WESTERN GREENBRIER CO-PRODUCTION DEMONSTRATION PROJECT

FINAL ENVIRONMENTAL IMPACT STATEMENT COMMENTS AND RESPONSES

ON THE DRAFT ENVIRONMENTAL IMPACT STATEMENT

DOE / EIS-036I

(Gore report p. 10)

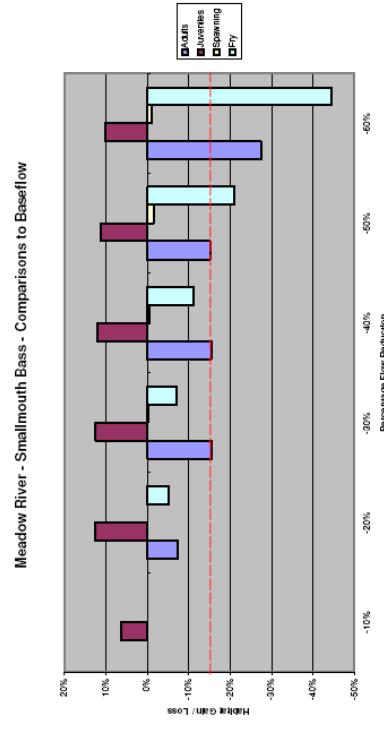
Dr. Gore also evaluated WUA for small mouth bass if withdrawals were made to 60% of mean daily flow. (Gore p.9)

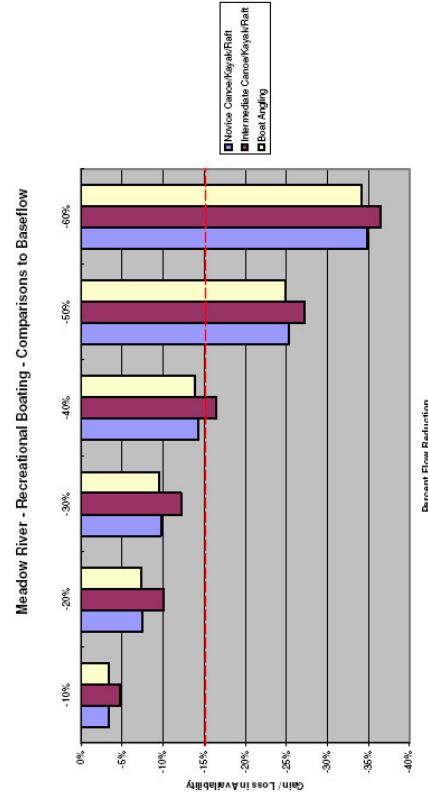
As is seen in the graph above (Gore report p. 13) intermediate boating will be significantly impacted as compared to that use at base flow as will other types of boating activities. While useful, the above graph compares recreational uses at base flow vs. the planned withdrawals below baseflow. The graph does not show the loss of use as compared to total actual flow.

Meadow River, McRoss, WV - Hydrograph

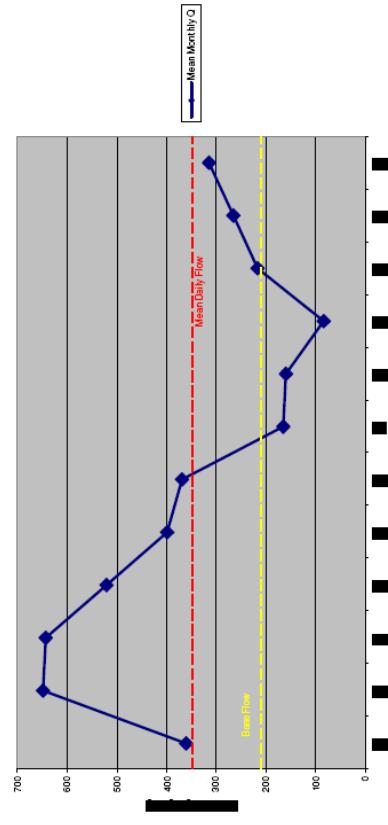
The hydrograph below (Gore, Meadow Comparison) helps to understand that comparison by showing the relationship between base flow (i.e. ground water contributions) and mean daily flow and mean monthly flow (closer to actual flow).
